MEMORANDUM

SUBJECT: SP20-131 Site Plan – Planning Review 1

LOT 6 PARKER AND PINE EVERBROOK ACADEMY SITE PLAN

LOT 6 PARKER AND PINE FILING 1
PARKER, CO
EVERBROOK ACADEMY SITE PLAN
ARCHITECTURAL ELEVATIONS

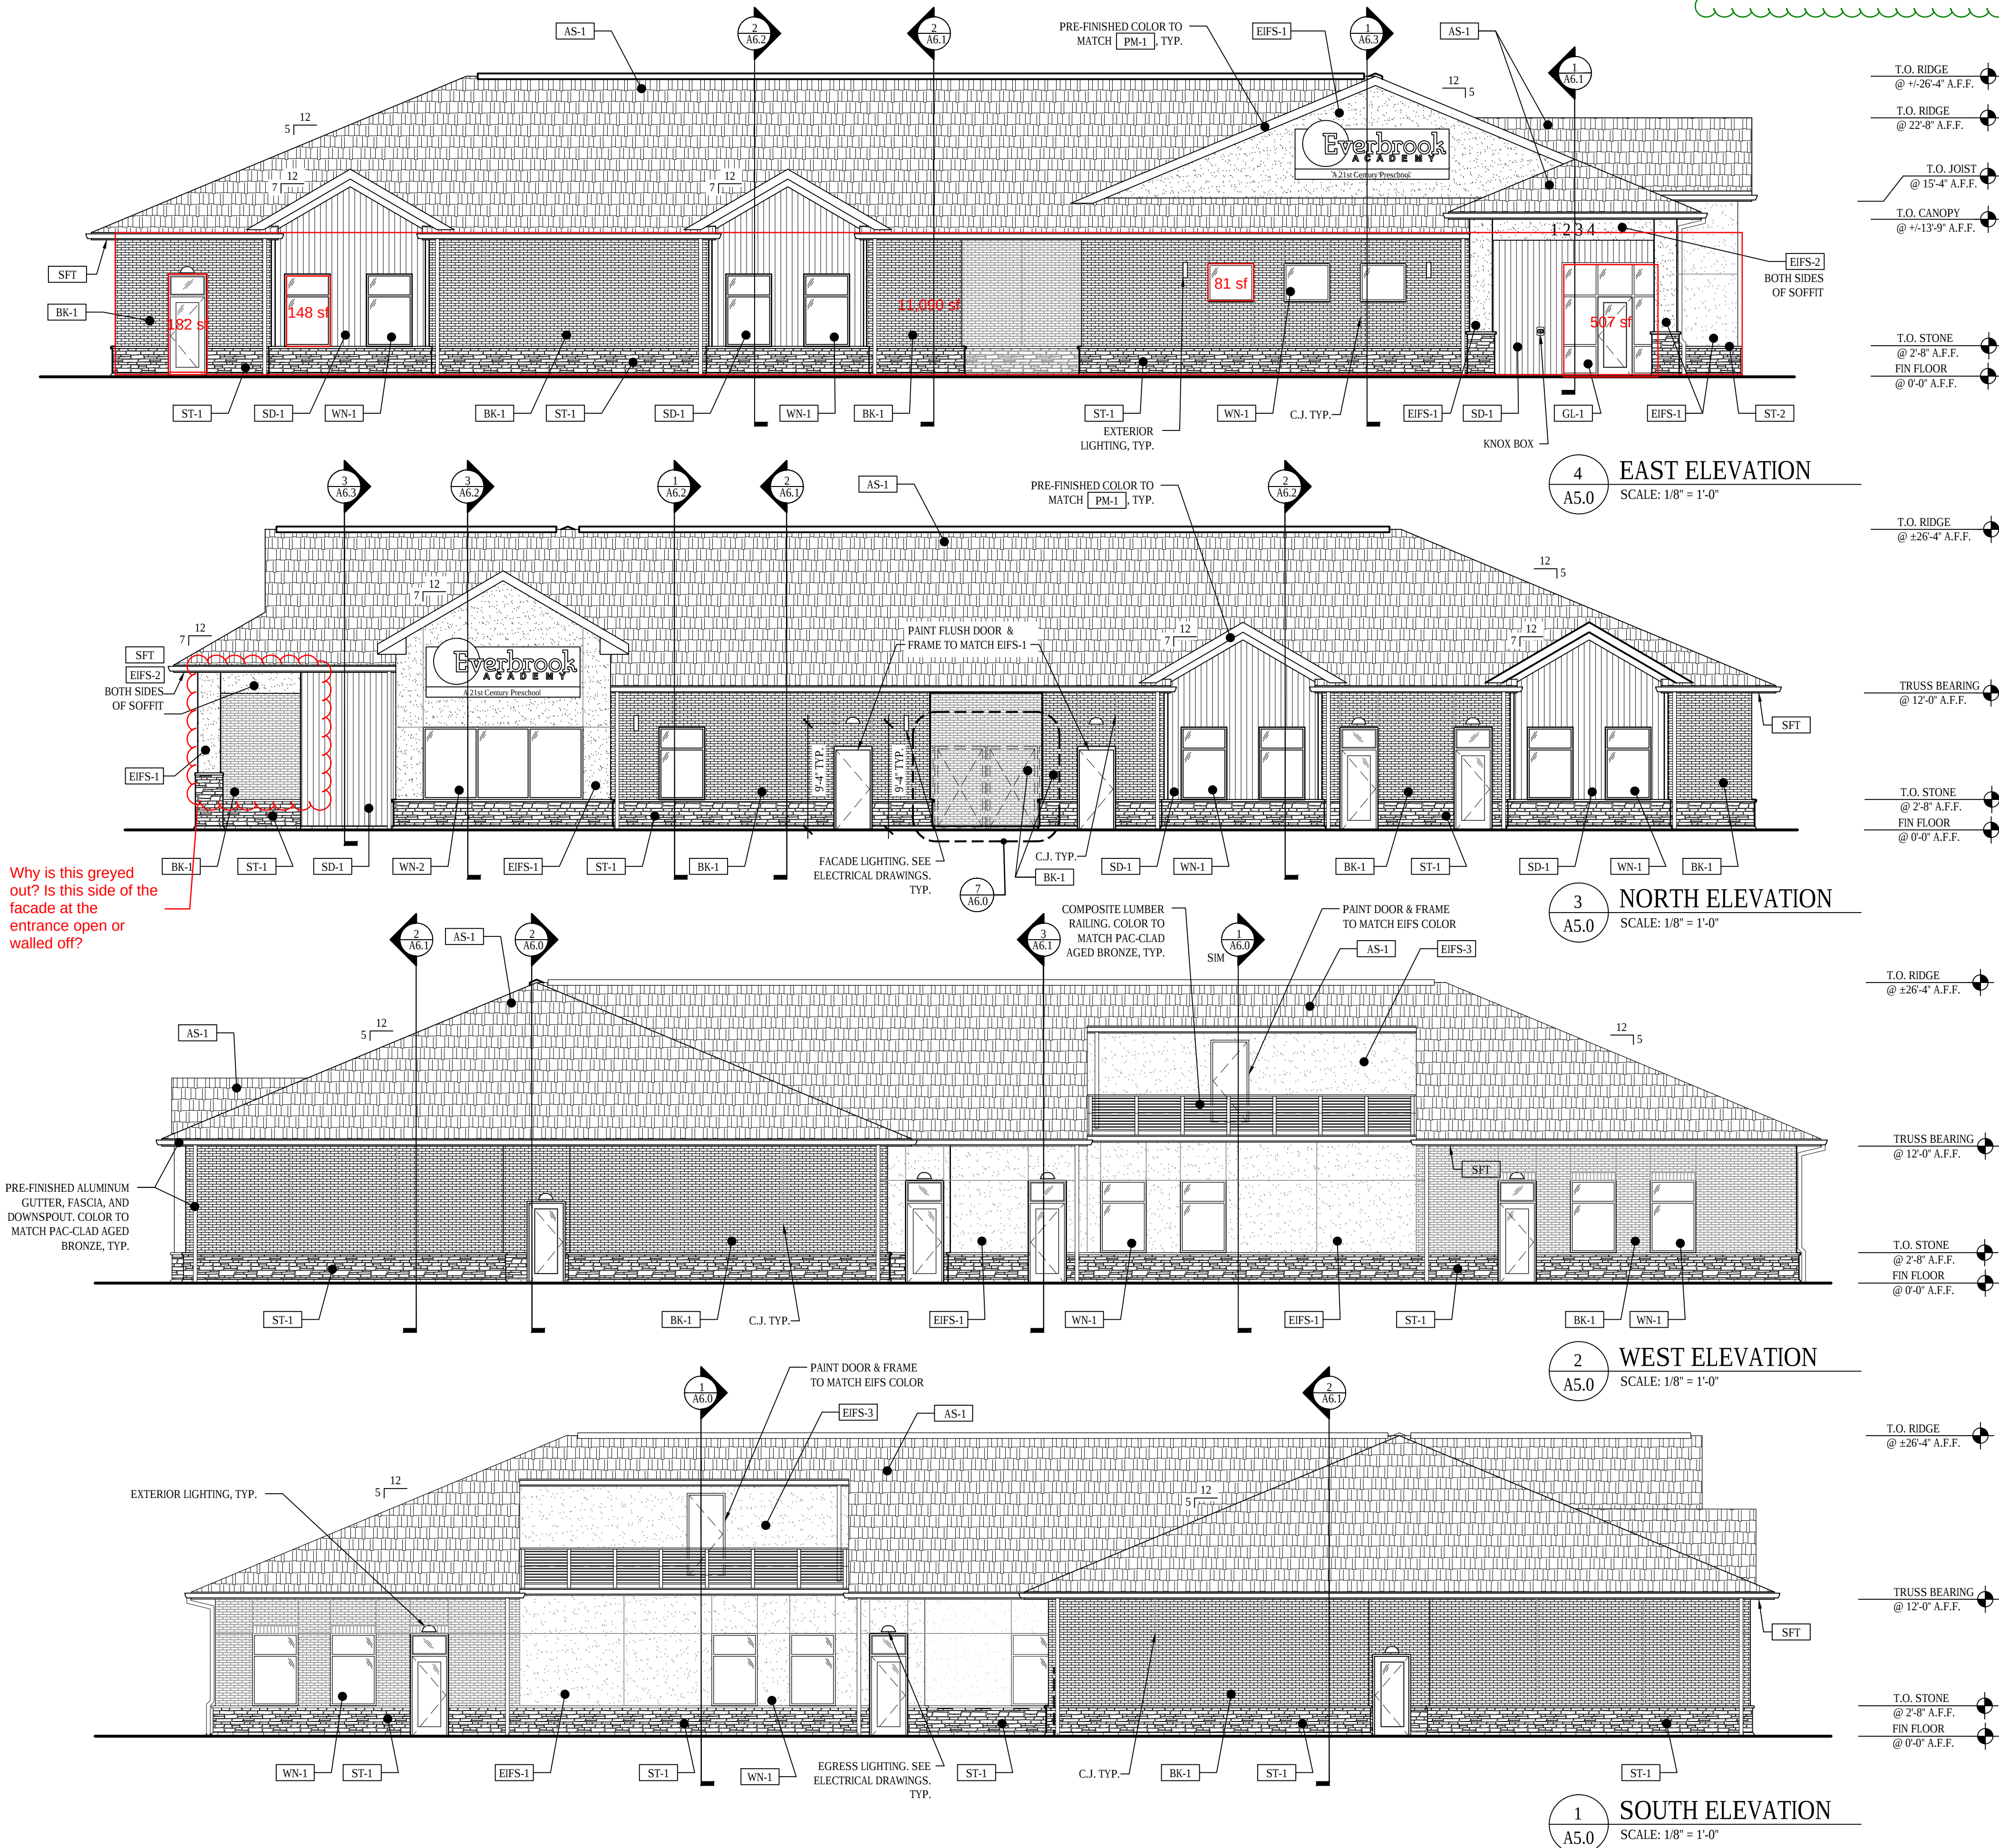
DDS pg 55 D Articulation and detailing is required where the roof meets the wall using cornices, eaves, or rakes as detailing. Moldings, brackets, exposed rafters of at least twelve (12) inches and finials shall be used to give the roof/cornice proper visual weight and proportion to the building (see figure 76).

draw to scale, provide scale.

Call out locations of all RTUs. Is the screening fence tall enough to fully screen all RTUs? Will any be wall mounted? Show location of any wall mounted utilities.

Provide a 3d rendering to show how wall setbacks align with roof changes. Provide multiple perspectives, but especially from the North/east and SouthWest angles.

exterior elevations where reviewed and coordinated with Krista Flynt. See revised sheet addressing comments.

Key plan is for elevation location only. Scale not needed. Refer to plan sheets for scaled drawings.

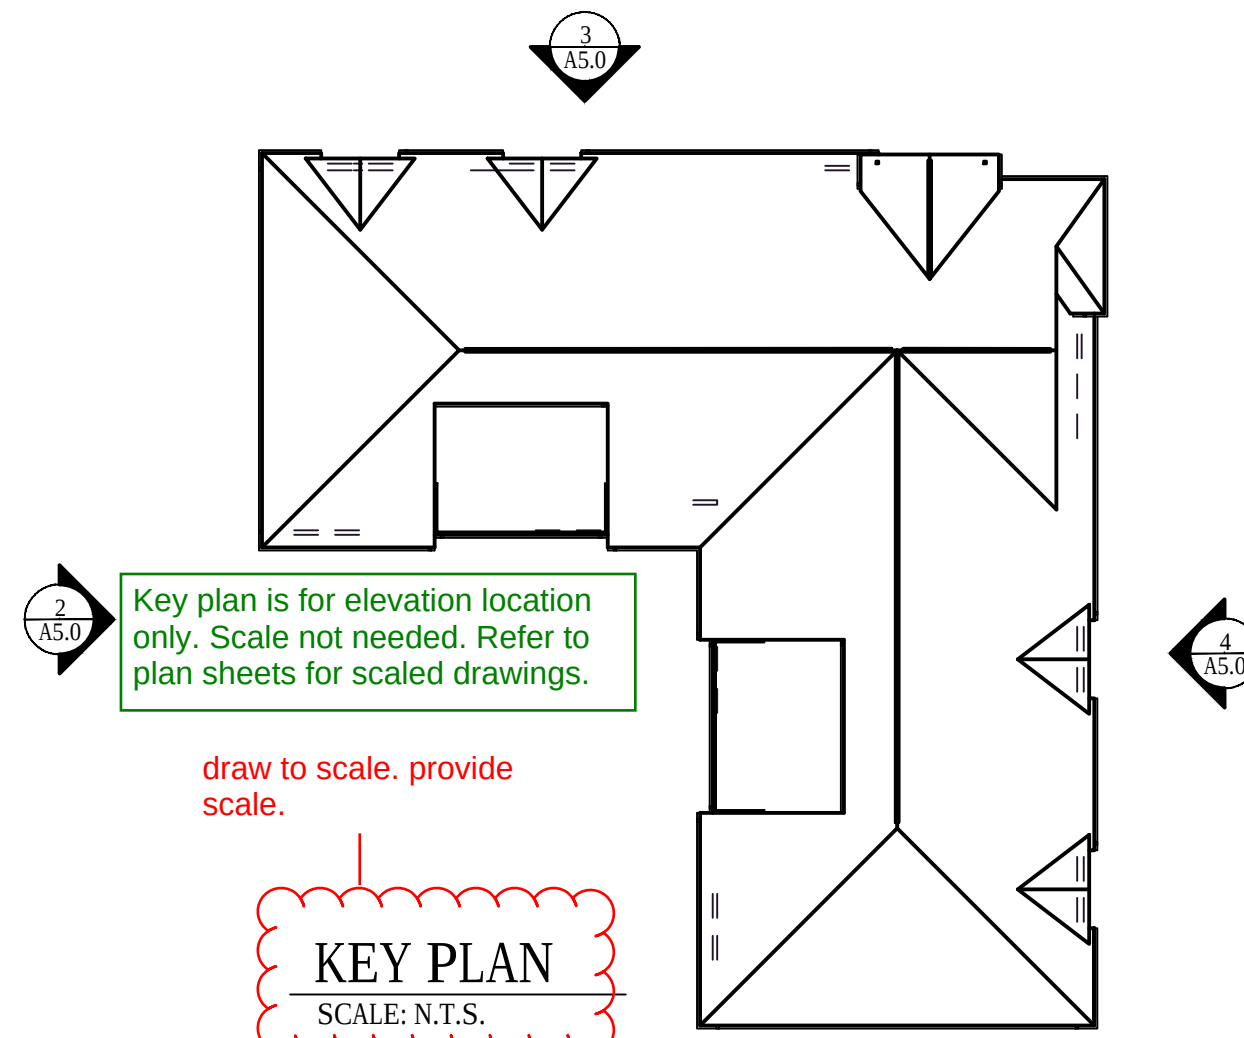
Please check your numbers. With rough measurements I got 1524sf of glazing and 11,090 sf of facade. That's 13.7% transparency. I will measure again when drawing is to scale.

Need 25%

See updated sheet with additional glazing area.

PARKER, CO
EVERBROOK ACADEMY SITE PLAN
ARCHITECTURAL MATERIALS BOARD

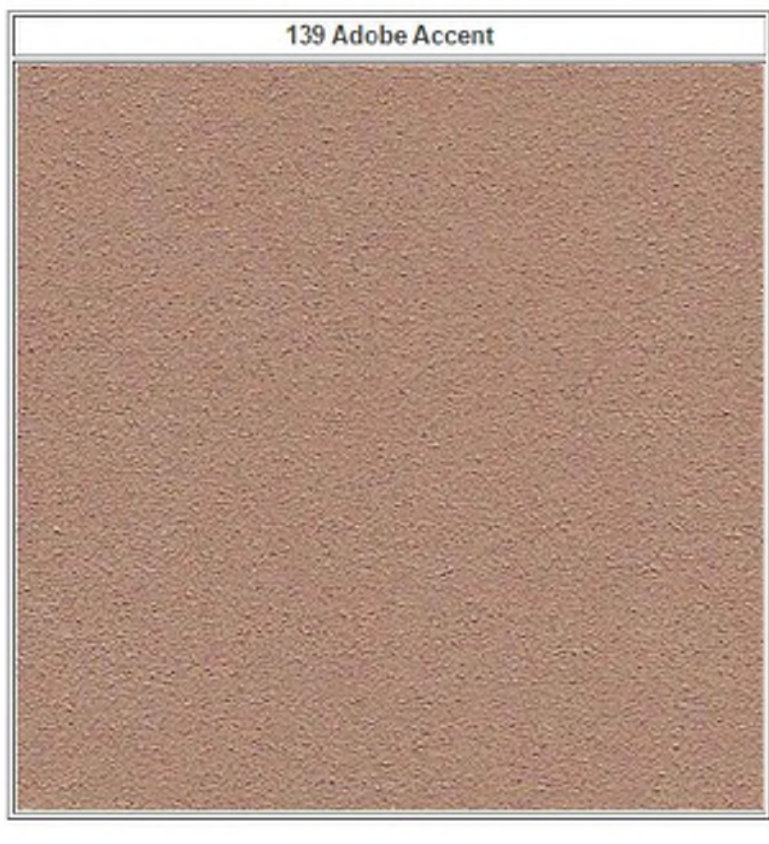
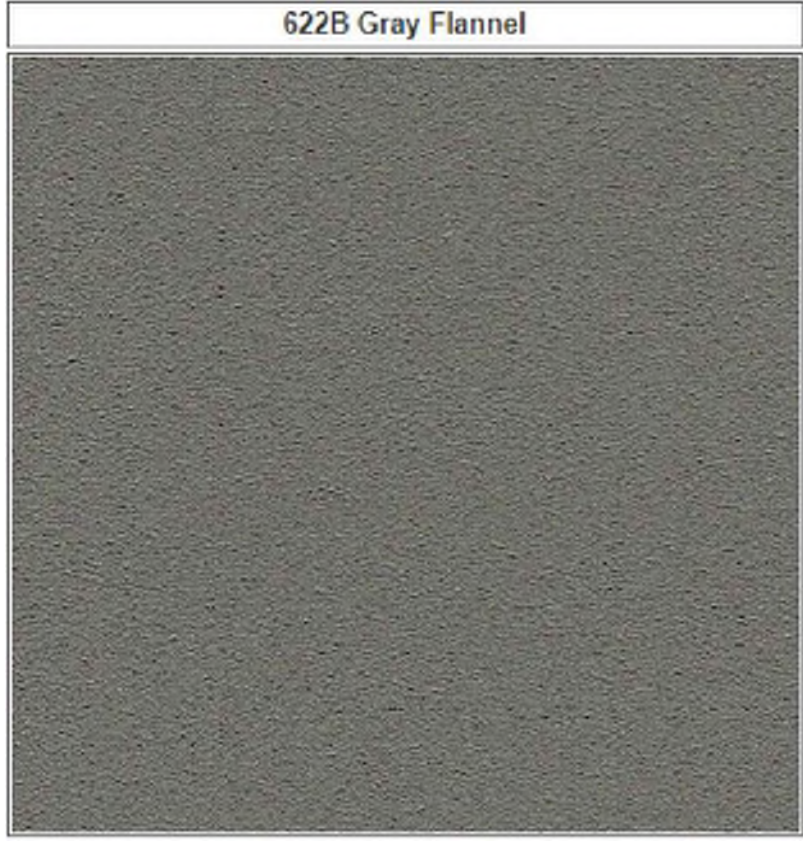
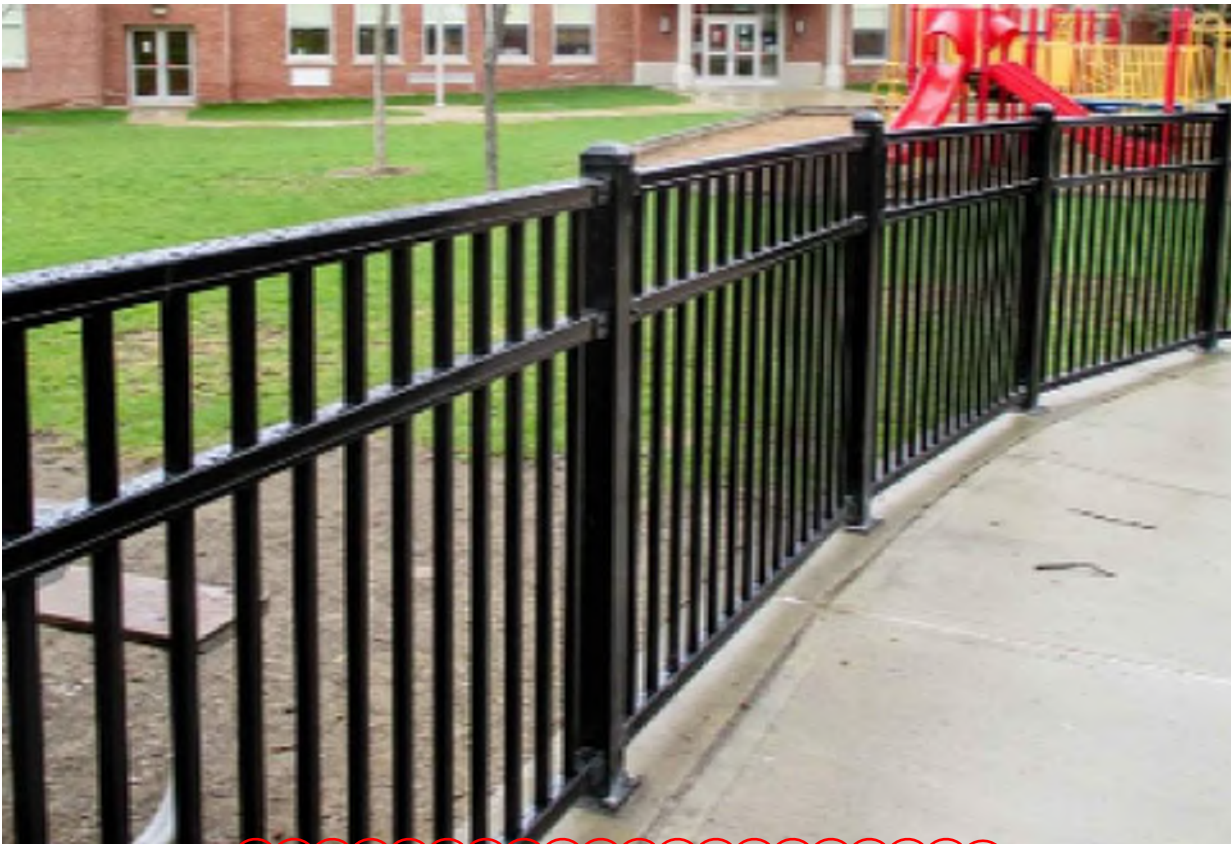
Provide materials and elevations for your retaining wall.

Provide frame material and color.

Height of fence? provide elevations

Show swatch and call out material of door and window frames. Must be black or grey metal.

Reviewed and coordinated with Krista Flynt. See revised sheet addressing comments.

see updated sheet
